UNITED STATES DEPARTMENT OF COMMERCE United States Patent and Trademark Office Address: COMMISSIONER FOR PATENTS P.O. Box 1450 Alexandria, Virginia 22313-1450 www.uspto.gov

APPLICATION NO.	FILING DATE	FIRST NAMED INVENTOR	ATTORNEY DOCKET NO.	CONFIRMATION NO.
10/711,842	10/08/2004	Markus Reiter	20067US	5841
23470 SRAM, LLC	7590 05/13/200	9	EXAMINER	
1333 N. KINGSBURY, 4TH FLOOR			IRVIN, THOMAS W	
CHICAGO, IL 60642			ART UNIT	PAPER NUMBER
			3657	
			NOTIFICATION DATE	DELIVERY MODE
			05/13/2009	ELECTRONIC

DETAILED ACTION

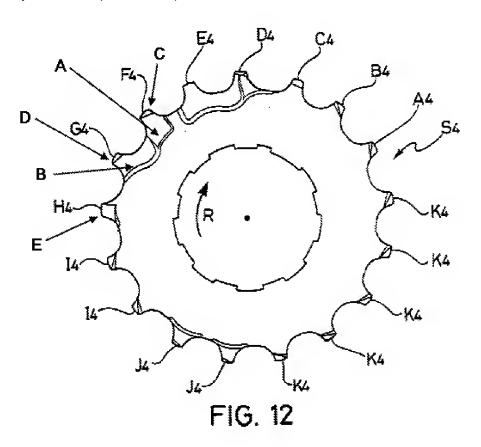
Claims 1-3, 5, 7-9, 12, 15, and 16 are rejected under 35 U.S.C. 102(b) as being anticipated by Kamada (6,340,338).

In Re claim 1, with reference to Fig. 3, 13, 14, and 12 (above), Kamada discloses a chainwheel assembly including a plurality of chainwheels (s1-s7) engageable with a chain (23) having successive alternating pairs of inner link plates and outer link plates connected by pins, the pins surrounded by rollers, the chainwheel assembly comprising: at least one smaller chainwheel (s3) having a plurality of teeth spaced about its circumference; and at least one larger chainwheel (s4) having a greater number of teeth spaced about its circumference than the smaller chainwheel, the larger chainwheel and the smaller chainwheel oriented relative to each other such that a distance between a center of the chain roller positioned between a pair of adjacent teeth on the larger chainwheel and the center of the chain roller between a pair adjacent teeth on the smaller chainwheel is substantially an integer multiple of the chain pitch, at least a first tooth (f4) of the pair of adjacent teeth (F4,G4) on the larger chainwheel includes a first lateral recess (A) having a first run-on ramp (see fig. 14), at least a second tooth (G4) of the pair of adjacent teeth disposed adjacent to the first tooth opposite the drive rotation direction including a second lateral recess (B) with a run-on ramp (see fig. 14).

In Re claims 2 and 3, see fig. 14.

In Re claim 5, see third tooth (H4) which includes a run-out chamfer (E).

In Re claim 7, see fig. 14.

In Re claims 8, 9, and 12, see deflection chamfers (C,D) on the first and second tooth (F4,G4) in fig. 12 above.

In Re claim 15, see fig. 3.

In Re claim 16, see chamfers (C,D,E).

In response to applicant's argument that that Kamada fails to disclose a run-on ramp configured to lift the outer link plate of a chain, a recitation of the intended use of the claimed invention must result in a structural difference between the claimed invention and the prior art in order to patentably distinguish the claimed invention from the prior art. If the prior art structure is capable of performing the intended use, then it meets the claim. In this case, the examiner believes that Kamada's recesses are understood to include run-on ramps that could lift the outer link plate of a chain as understood from the claim.

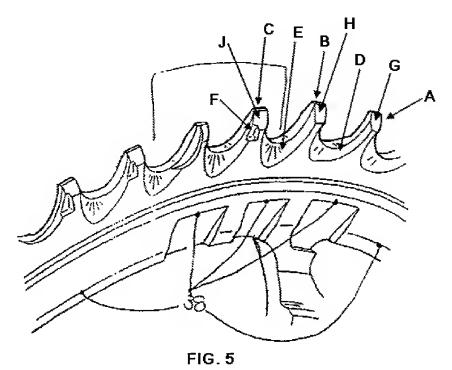
Claims 1-3, 5, 7, 8, 12, 15, 16, and 24 are rejected under 35 U.S.C. 102(b) as being anticipated by Yahata (2002/0086753).

In Re claim 1, with reference to Fig. 5, above, Yahata discloses a chainwheel assembly including a plurality of chainwheels (see fig. 15) engageable with a chain (10), the chainwheel assembly comprising: at least one smaller chainwheel (50) having a plurality of teeth spaced about its circumference; and at least one larger chainwheel (40) having a greater number of teeth spaced about its circumference than the smaller chainwheel, at least a first tooth (A) of a pair of adjacent teeth (A,B,C) on the larger chainwheel includes a first lateral recess and run-on ramp (D), at least a second tooth (B) of the pair of adjacent teeth disposed adjacent to the first tooth opposite the drive rotation direction including a second lateral recess and run-on ramp (E).

In Re claims 2 and 3, see fig. 5.

In Re claim 5, see third tooth (C) which includes a run-out chamfer (F).

In Re claim 7, see fig. 5.

In Re claims 8 and 12, see deflection chamfers (G,H) on the first and second tooth (A,B) in fig. 5 above.

In Re claim 15, see fig. 11.

In Re claim 16, see chamfers (G,H,J).

In Re claim 24, the recesses are separate from each other.

In response to applicant's arguments stating that "the recesses E and D of Yahata are on the back face of the larger chainwheel facing the next larger chainwheel"

the examiner points to figs. 15a-15c which clearly show "recesses" on the face of a larger chainwheel facing the next smaller chainwheel.
